Re: NPDES Permit No. NH0100170
(for) the Nashua Wastewater Treatment Facility

Subject: Nashua Wastewater Treatment Facility
Certification of NPDES Permit No. NH0100170

**RESPONSE TO COMMENTS
REISSUANCE OF NPDES PERMIT NO. NH0100170
CITY OF NASHUA
WASTEWATER TREATMENT FACILITY
NASHUA, NEW HAMPSHIRE**

Figure 1 Instream Chlorophyll *a* Concentrations – July 27, 2010 (from the *Upper Merrimack and Pemigewasset River Study Monitoring Data Report* (USACE December 2012))

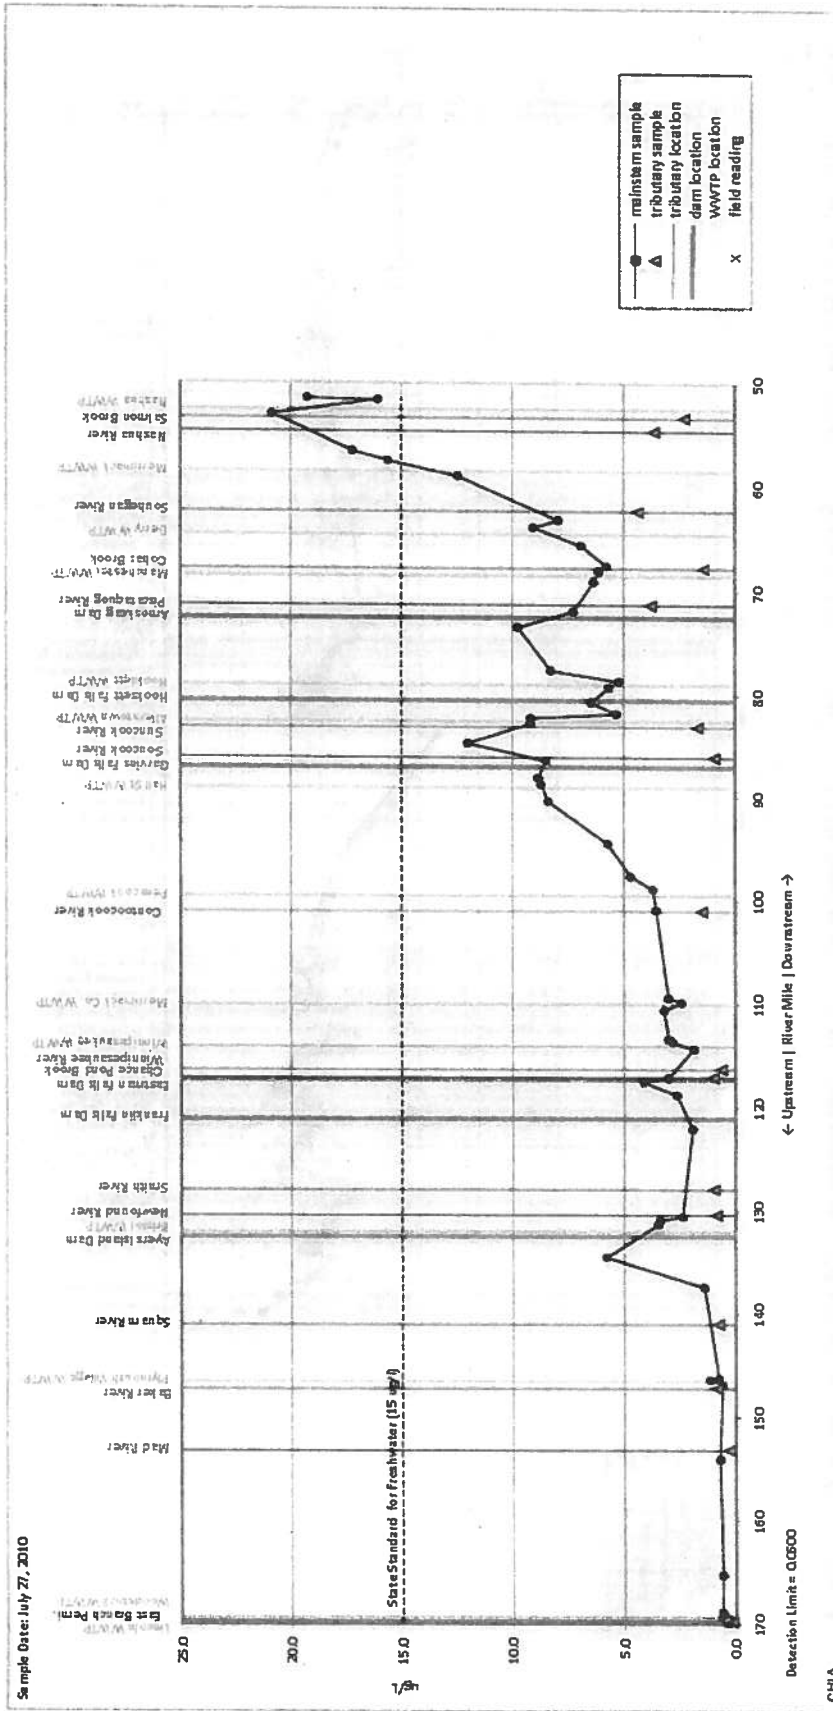
The Upper Merrimack and Pemigewasset River Study referenced in this comment includes the results of chlorophyll *a* and total phosphorus analyses that were conducted on samples collected upstream of the Nashua WWTF on July 27, 2010 and September 21, 2010. These results are depicted below in the Figures 1 and 2, and indicate an increase in instream chlorophyll *a* and total phosphorus concentrations in the vicinity of the Nashua WWTF. The conditions present in the receiving water on the sampling dates were observed when flows in the river were approximately 2.5 and 1.5 times (respectively) the 7Q10 flow, as measured at the nearest USGS gaging station located upstream from the Nashua WWTF (USGS gaging station No. 01092000, Merrimack River near Goffs Falls, below Manchester). One can reasonably expect that the observed conditions would be greater under 7Q10 flow conditions.
